PROPOSED TECHNICAL SPECIFICATION CHANGE

LICENSE AMENDMENT REQUEST

ENTERGY OPERATIONS, INC.

ARKANSAS NUCLEAR ONE, UNIT 2

### DEFORMED SNUBBER (Shown Fully Extended)

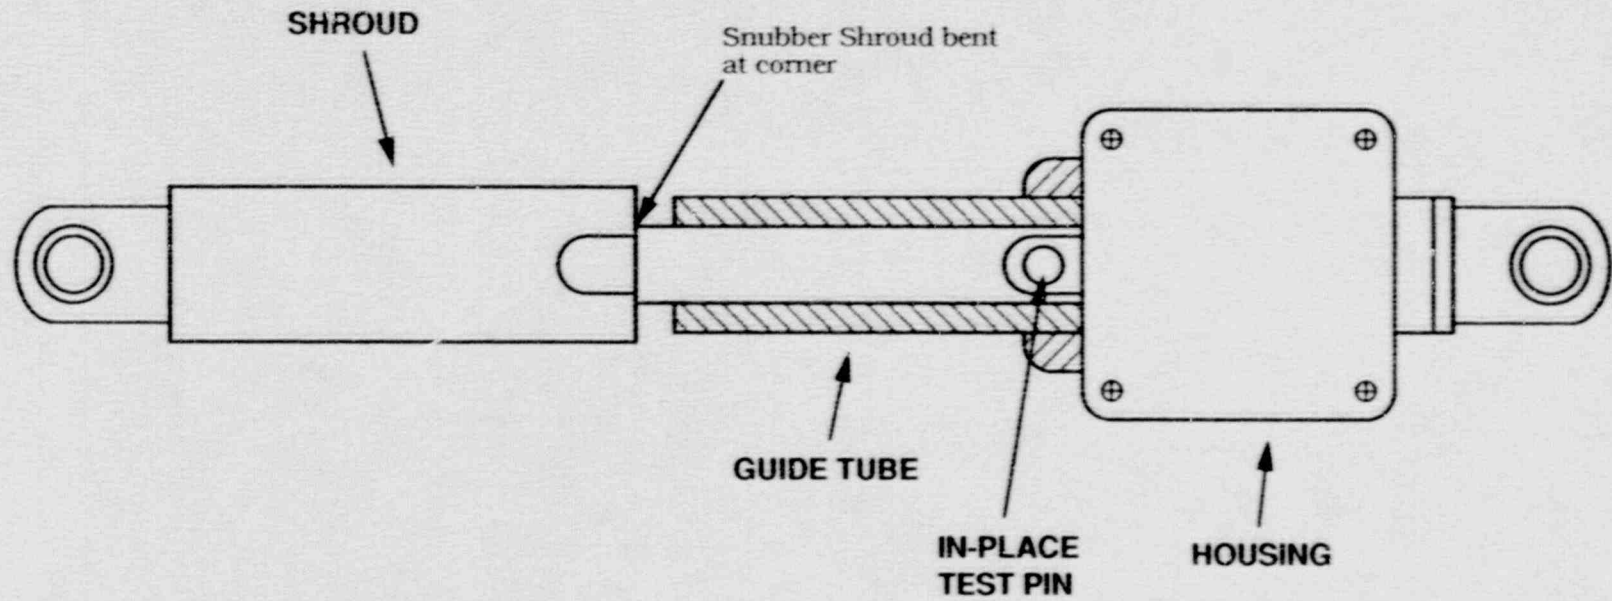
The snubber that failed the visual inspection was a mechanical Anchor-Darling snubber. The snubber was found fully extended with the corner of the shroud bent inward allowing a total movement of only approximately 1/8". In its fully extended position the shroud travels beyond the indicator tube approximately 1/8". When travel occurred in the compression direction, the corner of the shroud of the failed snubber caught on the guide tube bending it inward. This could only occur with the snubber fully extended.
